Swan and Canning Rivers Management Act 2006

DETERMINATION OF DEVELOPMENT APPLICATION

FILE NUMBER : SRT5719
APPLICANT : City of Gosnells
APPLICANT'S ADDRESS : Attn: Paul McAllister, Project Manager
PO Box 662
GOSNELLS WA 6990
LANDOWNER : Western Australian Planning Commission
LAND DESCRIPTION : Parks & Recreation reserve – Lot 901 on Plan 54943
Kenwick Link, Beckenham
DEVELOPMENT : Construction of an emergency operation centre for the
State Emergency Service & Bush Fire Brigade
VALID FORM 1 RECEIVED : 27 October 2014
DETERMINATION : **APPROVAL WITH CONDITIONS**

**Planning Development Application - 901L Kenwick Link, Beckenham -
Emergency Services Building**

Attachment 12: Elevation plan - proposed colours and finishes

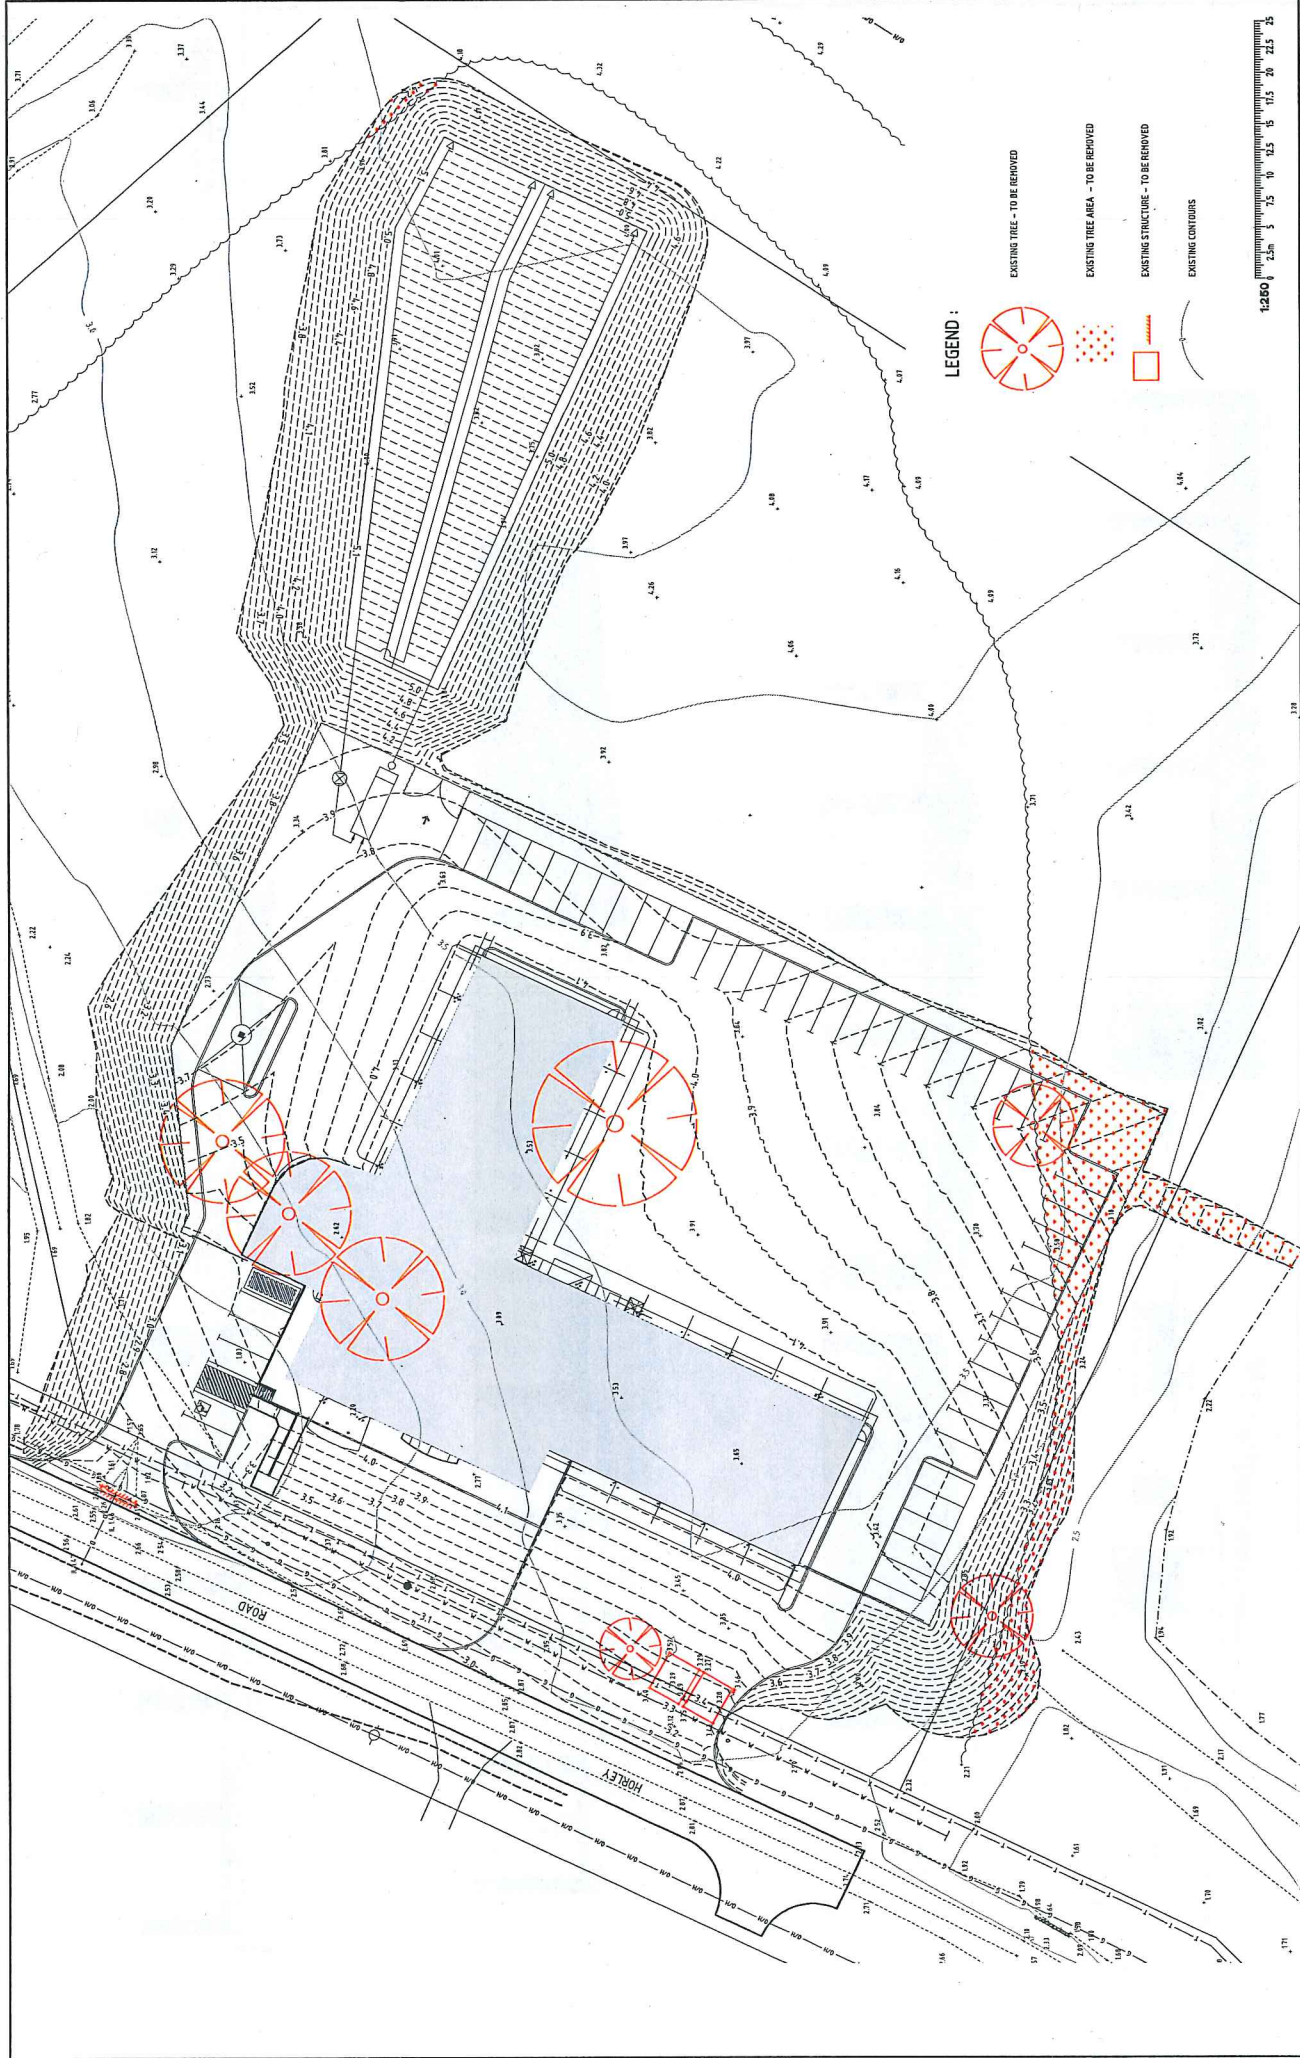
- 7.12 Colorbond sheeting is to be used for the two vehicle 'hangars' and ExoTec façade panelling for the office area, both with Colorbond roofs. The wall to the courtyard is to be rendered brickwork. The Elevation plan at **Attachment 12** depicts the proposed colours and finishes, which are to be dark earth colours and greens to harmonise with the riverine environment.

The Department of Planning on behalf of the Western Australian Planning Commission (WAPC) supports the proposal and does not require any specific conditions be imposed other than the building should be an appropriate colour green. The proposals for effluent disposal and the treatment and discharge of drainage water into the "constructed" wetland system to the south of the proposed development, which includes drainage from the Roe Highway, is acknowledged and also supported.

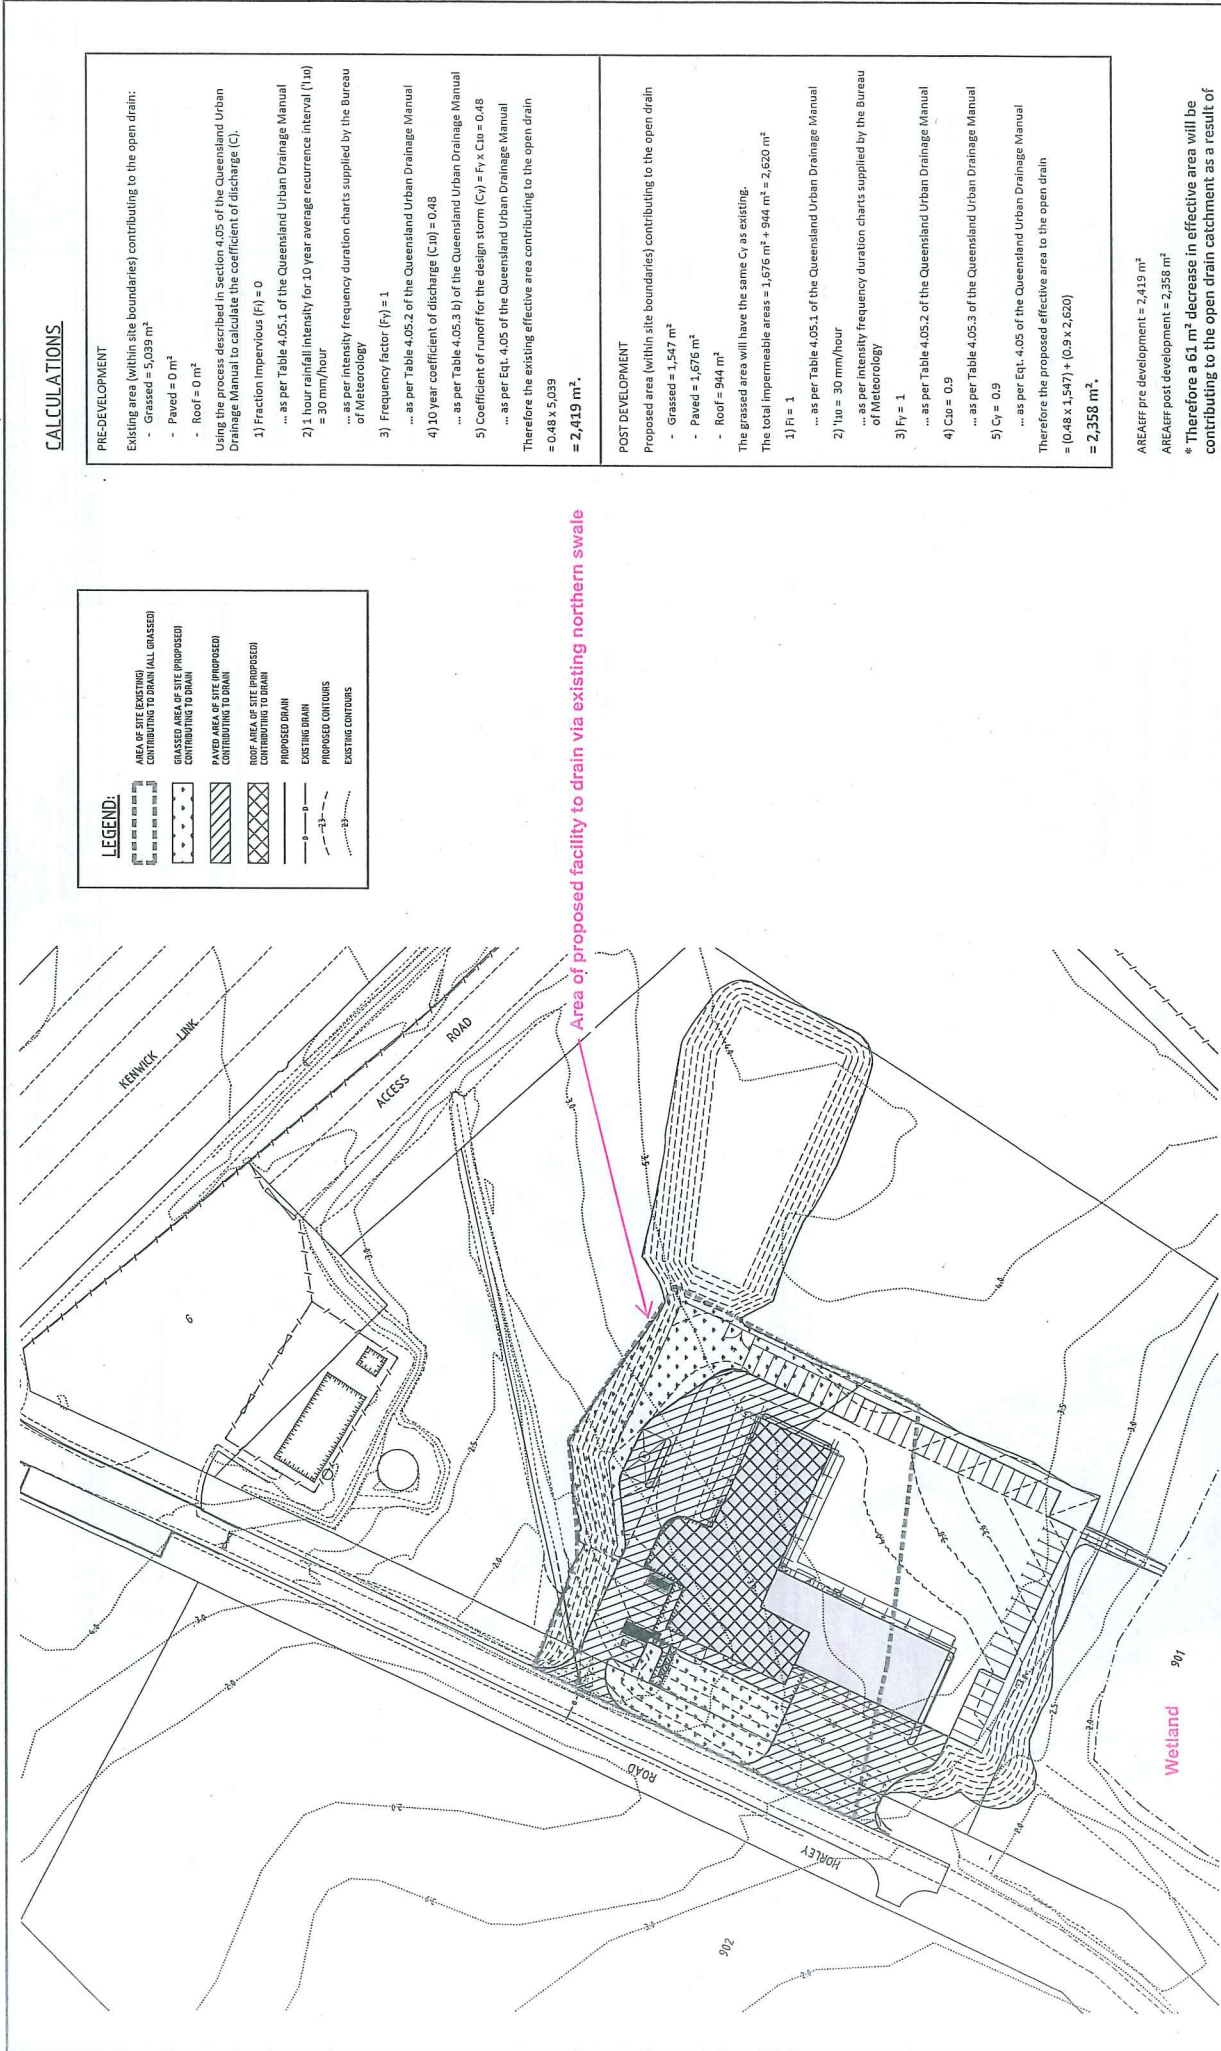
- 7.28 The runoff from the hardstand areas is proposed to be treated by means of a swale before being discharged to the wetland as shown at **Attachment 17**. Currently the southern swale is proposed only to be grassed with *Axonopus compressus* (Broadleaf carpet grass), however this is a weed species and will not provide for sufficient treatment prior to discharge to the wetland. The hardstand to the north of the site will be directed to an existing swale, which is proposed to be planted with *Ficinia nodosa* (Knobby Club Rush), *Juncus kraussii* (Sea Rush), *Juncus pallidus* (Pale Rush) at a density of 1 per 4m², and *Melaleuca lateritia* (Robin Redbreast Bush), *Viminaria juncea* (Swish Bush) at a density of 1 per 8m². Generally, design guidelines recommend 8-12 plants per m², depending on the species, to be effective at nutrient removal. The proposed planting densities will therefore need to be updated accordingly.

- 7.29 Consistent with the *Decision process for stormwater management in WA* (DoW, 2009) treatment of stormwater from a 1:1 year ARI rainfall event should occur as high in the catchment and as close to the source as possible (i.e. before runoff leaves the site). Dedicated treatment areas and systems which have a detention, settlement capacity, and plants of a species and density to be effective at the removal of nutrient, particulates, and hydrocarbons in the water, is therefore required. The treatment of the swale must also contribute to the ecology of the wetland and as such endemic species should be used. It is considered necessary for a Stormwater Management Plan (SMP) to be prepared and implemented for this project.

5. Information provided indicates that the swale, grassed with broadleaf carpet grass *Axonopus compressus*, serves as a conduit only, delivering car park runoff directly to the reconstructed wetland to the south of Lot 901, with no detention or settlement capacity to provide for the removal of nutrients or particulates. This is not considered acceptable. Further the use of this grass is not considered appropriate within the previously revegetated edge of the reconstructed wetland. It is regarded as an environmental weed in Queensland and New South Wales and is considered potentially risky in the context of its potential spread. The treatment of the swale must contribute to the ecology of the wetland and, as such the use of native vegetation is recommended.

7. Consistent with the *Decision process for stormwater management in WA* (DoW, 2009) treatment of stormwater from a 1:1 year ARI rainfall event should occur as high in the catchment and as close to the source as possible (i.e. before runoff leaves the site). Dedicated treatment areas and systems are therefore required. The current design provides little or no detention or settlement capacity or plants of a species and density to be effective at the removal of nutrients, particulates or hydrocarbons. Details on the management of runoff from Horley Drive are also required. As previously advised, the use of *Axonopus compressus* (Broadleaf carpet grass) is not considered appropriate, particularly within the buffer of the wetland. This grass is regarded as an environmental weed in Queensland and New South Wales and is considered potentially risky in the context of its potential spread. The treatment of the swale must contribute to the ecology of the wetland and as such the use of endemic vegetation is recommended. To improve water filtration processes and mitigate any potential impacts to the water quality of the Canning River, it is appropriate for the wetland to which stormwater from the development is being discharged also be revegetated wherever possible. The stormwater design is required to be endorsed prior to the lodgement of a Building Licence.

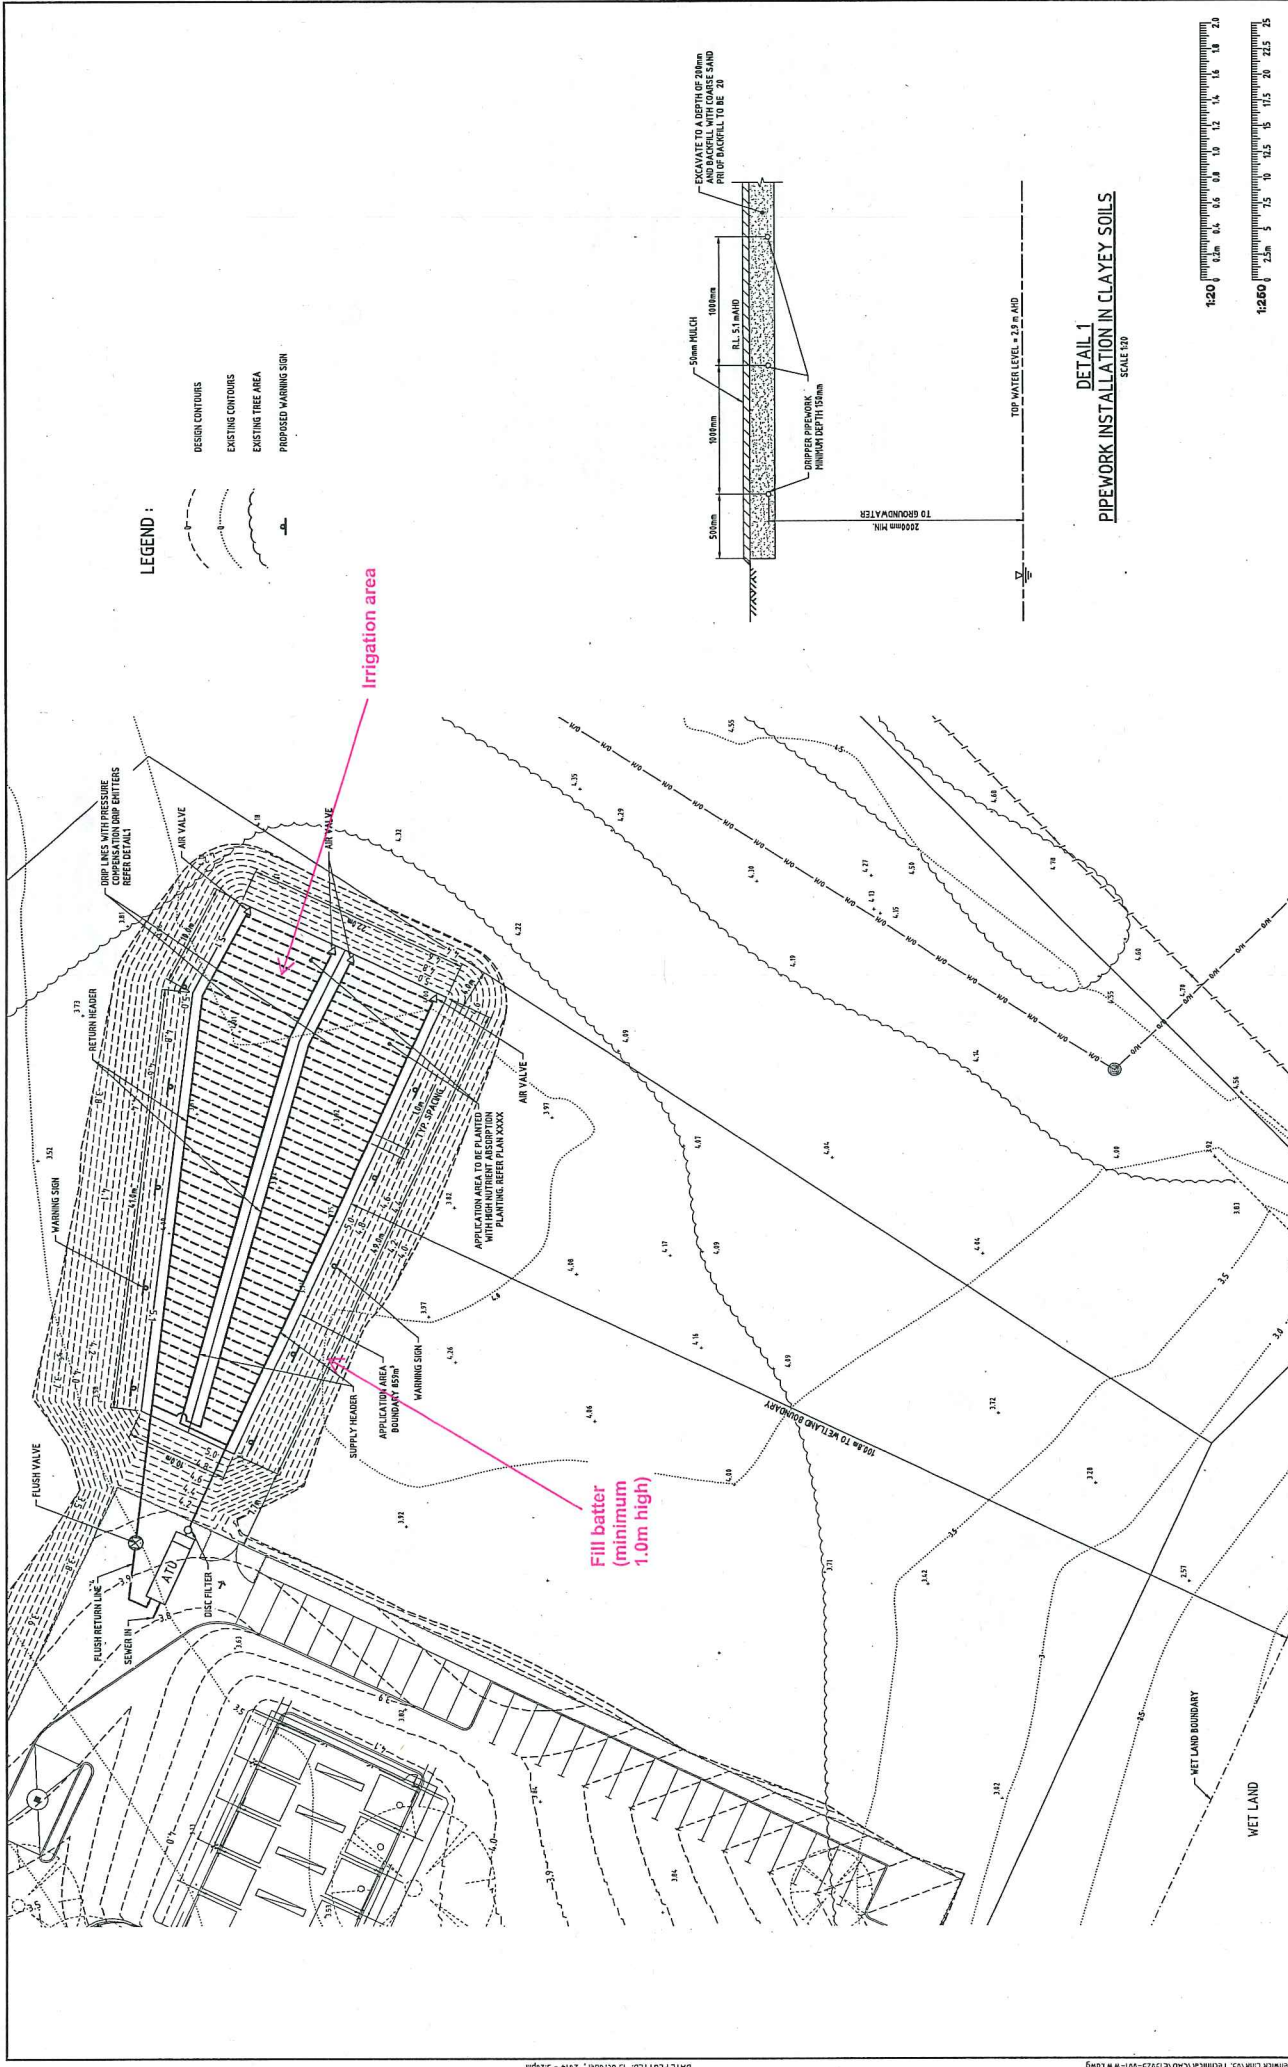
- 7.32 The Applicant has proposed to use an Aquarius O-3 8KLC Aerobic Treatment Unit (ATU) to treat an estimated 7,100 L/day of wastewater from the facility. The manufacturer advertises that the system treats the wastewater to <1mg/L total phosphorus (TP) and <10mg/L total nitrogen (TN). This effectiveness is only assured if regular maintenance is conducted. For comparison, the Trust's Healthy Rivers Action Plan identifies a short-term nutrient concentration target in catchment tributaries of 2.0mg/L TN and 0.2mg/L TP and a long-term target of 1.0mg/L TN and 0.1mg/L TP.

- 7.33 The treated water is proposed to be discharged to a surface irrigation disposal area, planted with *Eucalyptus rudis* (Flooded Gum), *Melaleuca preissiana* (Stout Paperbark), *Melaleuca raphiophylla* (Swamp Paperbark) at a density of 1 per 34m² and *Melaleuca lateritia* (Robin Redbreast Bush) at a density of 1 per 13m². The irrigation area is approximately 100m from the wetland at the site and will be fenced off. Due to the clay nature of the site, the Applicant will excavate the irrigation area to a depth of 0.5m and backfill with coarse sand. The phosphorus retention index (PRI) of the backfill will be 20. The proposed wastewater system is shown at **Attachment 18**. For the onsite disposal of effluent, the Trust expects that any irrigation area be planted with high nutrient absorption species at an appropriate density to improve the quality of the water being discharged. As discussed above, general design guidelines recommend 8-12 plants per m², depending on the species.

The proposed surface irrigation disposal area is proposed to be planted with Banksia and Hakea spp. This is at odds with the surface irrigation area being the final stage of disposal, and treatment, for a system that receives waste water that is potentially infected with Dieback. In this regard, it has not been demonstrated how the ATU will treat dieback infected waste water. The plan for the wastewater disposal method indicates the need for the disposal area to be planted with high nutrient absorption species. The proposal to plant Proteacea species in this area is at odds with the need for plants to potentially assimilate nutrients as many Proteaceae species are not very tolerant to nutrients.
